Investigation into the remediation of the contaminated site at Mapua

Air technical annex

Figure 2: A schematic diagram of the MCD plant and associated AECS

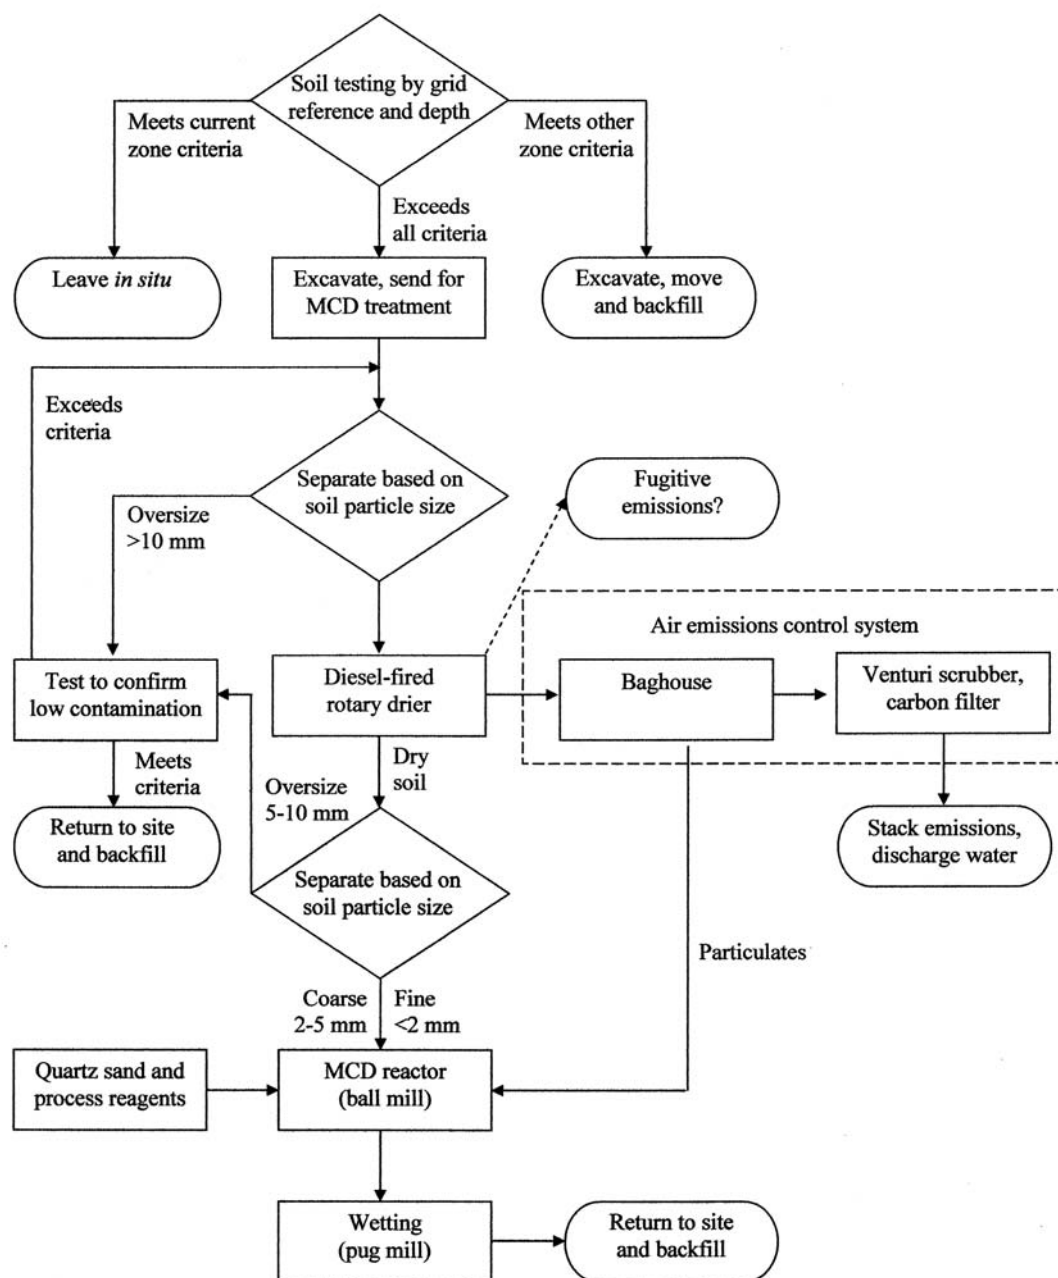
[Figure 2](#) shows a schematic diagram of the Mechano-Chemical Dehalogenation (MCD) plant and the associated Air Emissions Control System (AECS). The AECS is designed to remove toxins formed in the drier and other parts of the MCD plant from the gaseous emissions of the plant. Fugitive emissions are those emissions which are emitted into the atmosphere from the drier or other parts of the MCD not via the AECS.

Within the MCD, there are two main sources of emissions – one from the soil drier, and the second from the reactor itself. Both have short and direct paths to the atmosphere (via screw conveyors), although the reactor seems to have a design feature enabling conveyors to act as devices to relieve transitory air pressure rises in the reactor. In terms of emissions from the reactor or the drier, under expected operating conditions the design of the system would seem to minimise any emissions that could occur from the

reactor except via the AECS. Under normal operation, about $2 \text{ m}^3 \text{ s}^{-1}$ of air was passing through the system and the flow was fan forced (the fan was at the front end of the process). In addition, on the far side of the bag-house there is an additional fan to induce flow. However, in the first year of operations there were back-pressure issues within the system,¹⁶ where the resistance of the AECS was such that the pressure within the system increased. This seems to have been caused by the substantial back pressure from the baghouse and carbon filter. In this situation, air can be forced back through the drier. Under these circumstances, it is likely that fugitive emissions from the drier could occur. These emissions would likely have been discharged into storage shed ST120. It is also worth noting that the “effective seals”¹⁷ between the storage shed ST130 and the drier do not mean ‘pressure tested’. So some of these fugitive emissions from the drier may have been emitted into the open.

In his brief of evidence,²² he set out that the air emissions control system was to consist of cyclone separators, a bag filter, a venturi water scrubber, a packed bed scrubber and two activated carbon filters in series.²³ The air stream from the dryer that would potentially contain toxins and dust from the soil was to be passed through the air emissions control system before release from the stack, (see [Figure 2](#)).

There are questions as to whether the AECS actually installed was as described at the hearing. It should be noted that the configuration of the AECS was changed in during July–November 2005.

When the plant with the installed AECS was put through its Proof of Performance testing, it consisted of cyclone separators, bag-house, venturi scrubber and a single carbon filter.²⁴ The components of the AECS were not as described by Simon Oakley, the packed bed scrubber and a carbon filter (see below) seem to be missing. It seems that the AECS was not installed in accordance with the AEE and therefore potentially breached resource consent condition 17.

The answer to the question about whether the plant as built worked is clearer. The plant as first installed had a single carbon filter rather than a pair in series. This reduced both the capacity and security of the VOC removal part of the system. It has been argued by EDL²⁷ that a single carbon filter was sufficient, because the plant only ran for 12 hours per day. The two carbon filters (as presented at the hearing) were necessary because at that time it was envisaged that the plant would run for 24 hours a day. This, however, is not consistent with another EDL statement on the matter.²⁸ It also seems clear that, on the basis of noise alone, even before the hearing it was obvious that a plant such as this could not be run for 24 hours a day in a residential area. Both high humidity and/or high temperature of the gas stream would have compromised the performance of the carbon filters. In the configuration as originally installed (even if nothing else had gone wrong), it is unlikely that the carbon filter would have worked efficiently.²⁹ However, as the carbon filter failed a number of times, the question is answered.

A further point concerns the lack of a packed bed scrubber. The role of this unit would be to remove gases and particulates and – possibly by increasing the volume of the system – contribute to system stability. Its absence will have affected the performance of the plant in those two ways.

In the event, the drier was run much hotter than the specified 120°C, producing hotter gases and more VOCs, and both reducing the efficiency of the carbon filter and increasing the job it had to do. In addition, the corrosive nature of the gases running through the system was much greater than anticipated, which ultimately led to the complete failure of the carbon filter on some occasions, and the plant running without it. This indicates that the system as initially installed did not work properly.

During the period July to November 2005, the system was modified, redesigning the carbon filter and moving it ahead of the venturi scrubbers. (This reduced the humidity reaching the carbon filter, increasing its efficiency). The flow through the filter was also reversed (to reduce the back pressure in the system). This then exposed it to higher
